**Applicant's Post Hearing Submissions
(CAH, ISH 2 and ISH3)
TN 42 Station Drive Closure**

The West Midlands Rail Freight Interchange Order 201X

WEST MIDLANDS INTERCHANGE

Transport Technical Note 42 – Impact of Closing Station Drive at the Rail Bridge.

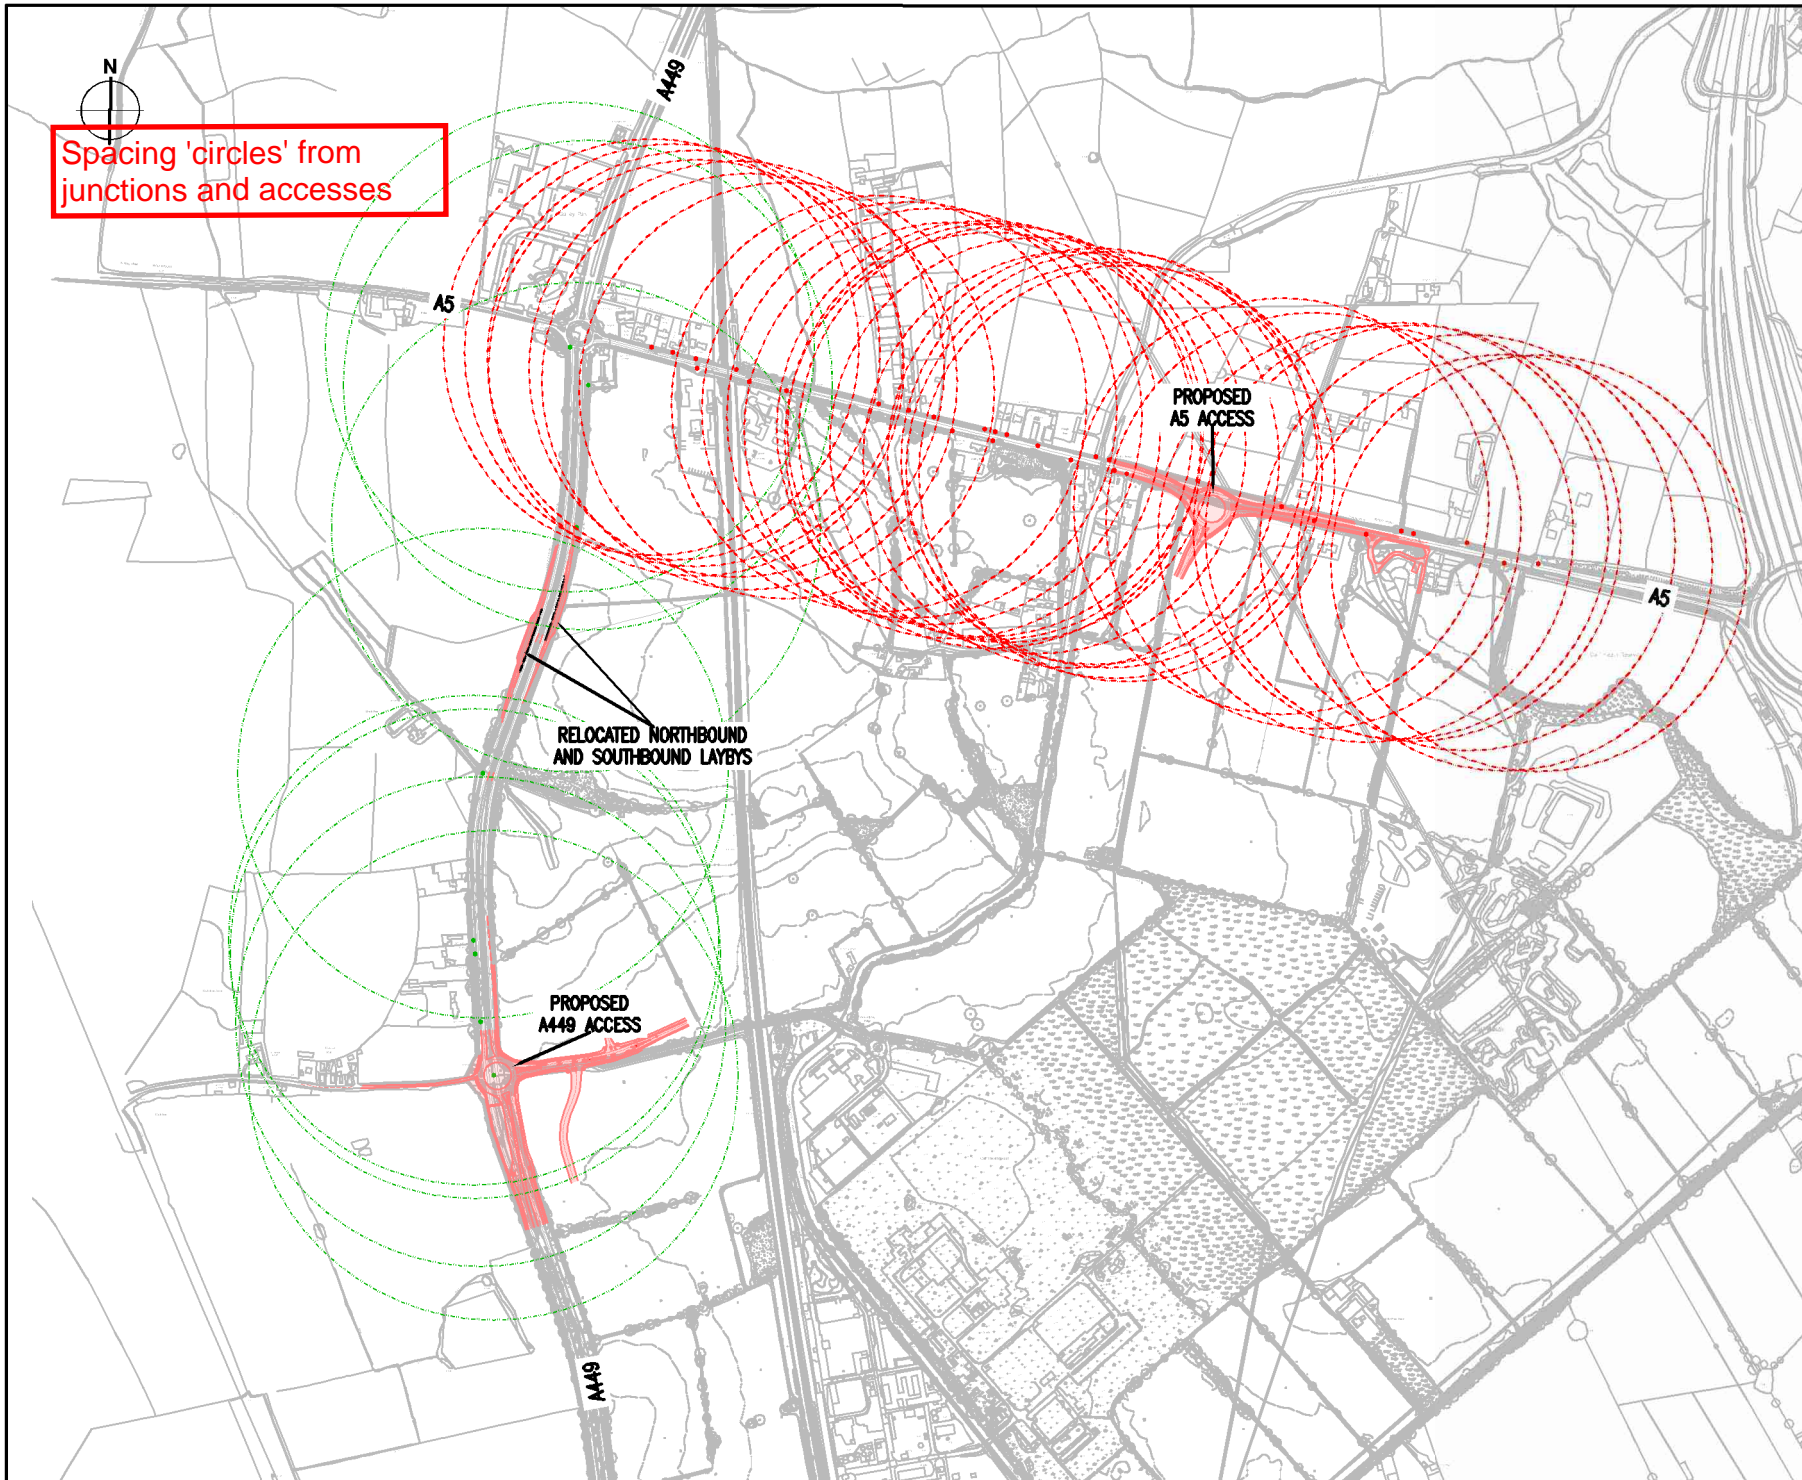
- 3.6 As can be seen from the attached Drawing 70001979-DS-06 (**APPENDIX B**) which shows the separation distance of 319m from accesses both up and downstream, there is nowhere on the A5 between the M6 and the A449 that can sensibly accommodate a pair of lay-bys. To the east of the M6 there is insufficient land width to provide compliant sized lay-bys and a short distance east of the M6 lies The New Hollies Truck Stop which already provides significant lorry parking. Similar constraints exist on the A5 to the west of the A449.

- 3.7 It is therefore proposed the lay-bys are placed on the A449, where as shown by drawing 70001979-DS-06 the density of accesses is less. It also has the advantage of being a dual carriageway which physically prohibits right turn in and out of the lay-bys and are consequently considerable safer than the current arrangements.

Drawing No. Rev.
WSP-70001979-GA-105 E

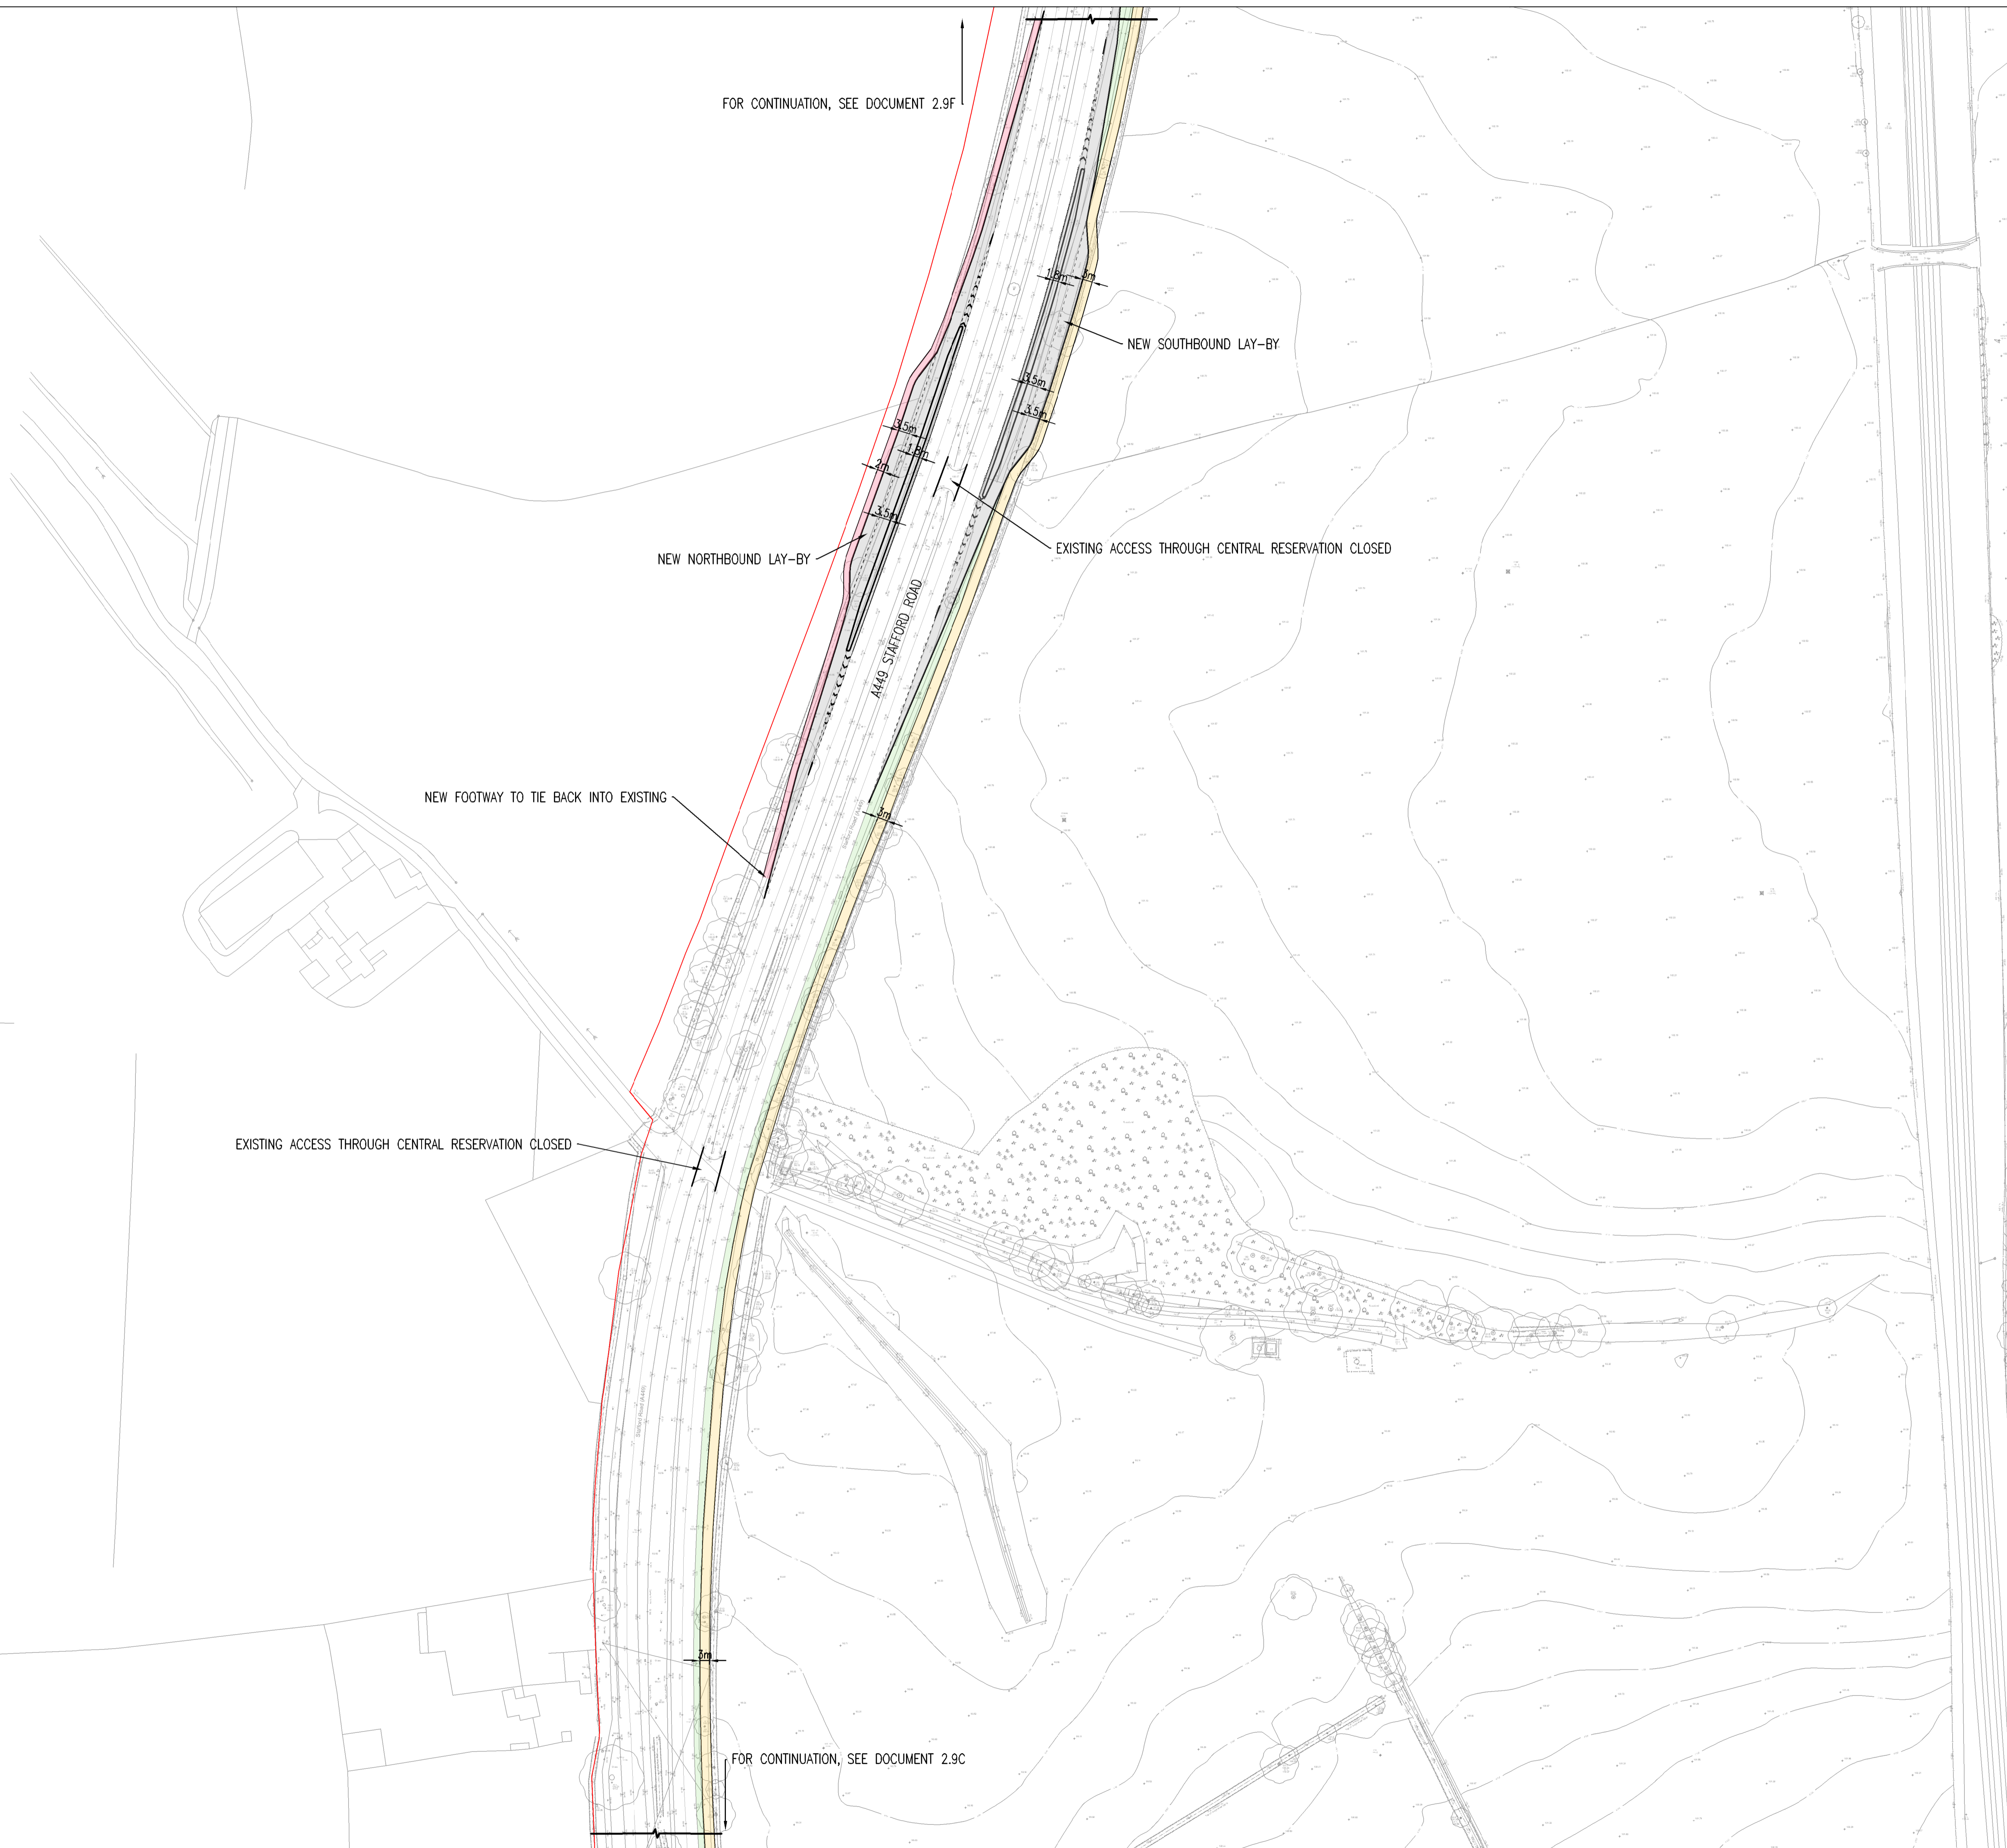
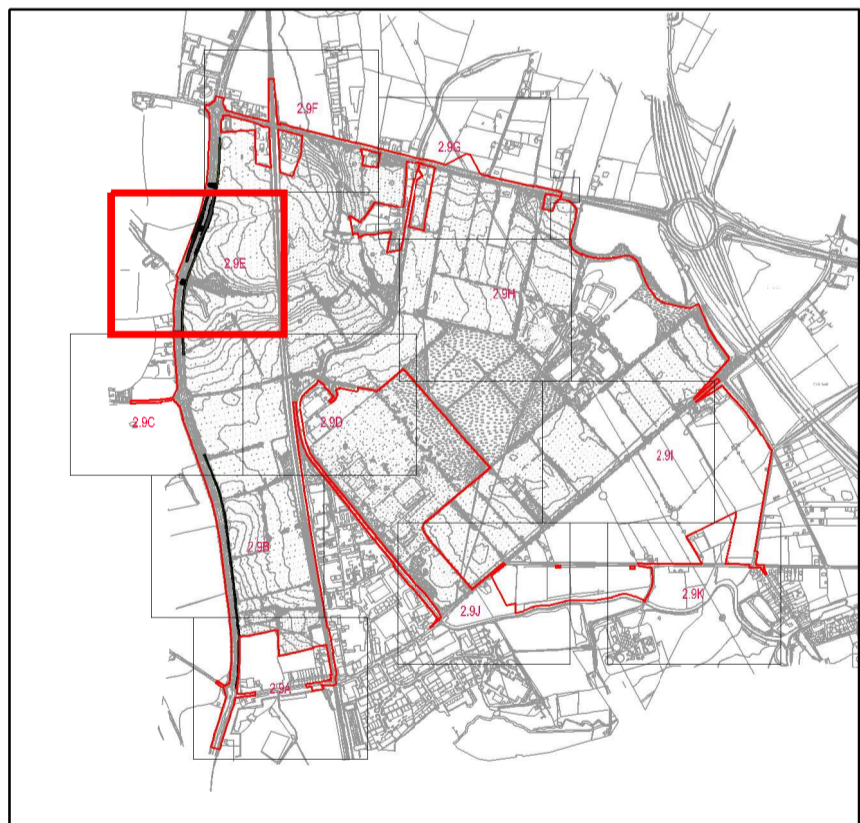
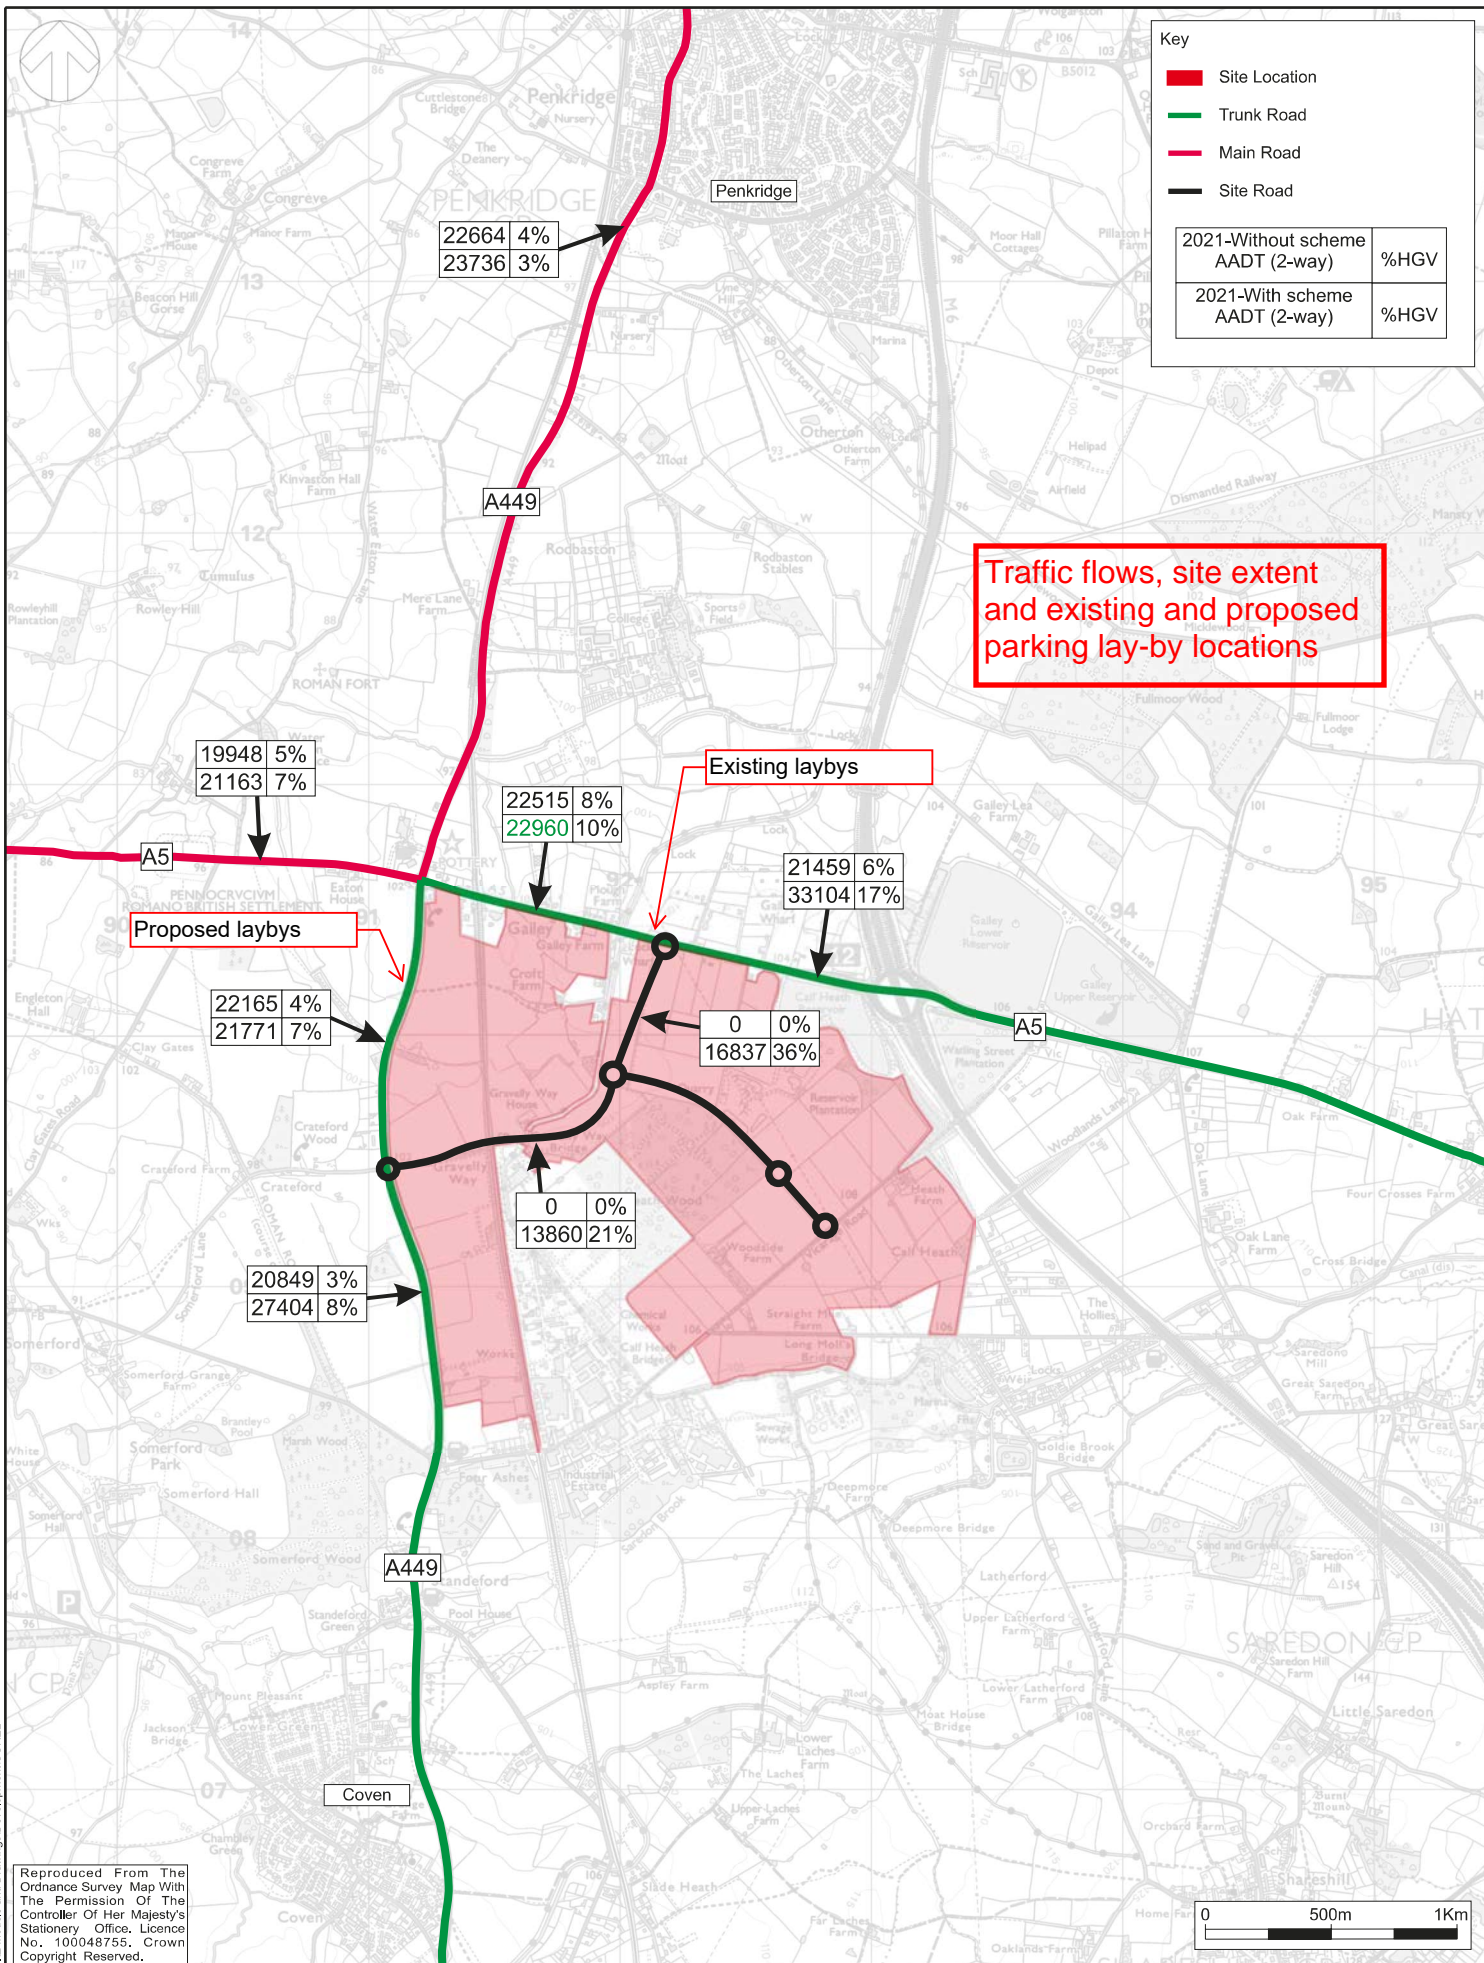
- 3.15 The new lay-by arrangements are shown on WSP drawing 70001979-GA-105 Revision E which is contained in **APPENDIX C** at the end of this document.

- 3.16 Comment has been made previously by HE by way of e-mail dated 19 September 2017 that the existing A449 northbound layby at Coven Heath may be closed and that the possibility of extending the proposed A449 layby should be explored. This exercise has been carried out and whilst theoretically the storage length could be extended to 100m (the maximum permitted by TD69/07) and accommodated within land that is under the control of the Applicant, this would bring the upstream separation distance closer to Gailey Roundabout by approximately 60 metres. This would have the potential to impact upon the departure from designs standards submission should it be taken further, which when considered that it should not be necessary for the proposed laybys to deal with anything other than the impact of the Proposed Development, is not considered reasonable. As specified later within this document, it is demonstrated that it is not necessary to provide a greater length at the proposed relocated laybys than is already provided by the existing laybys.
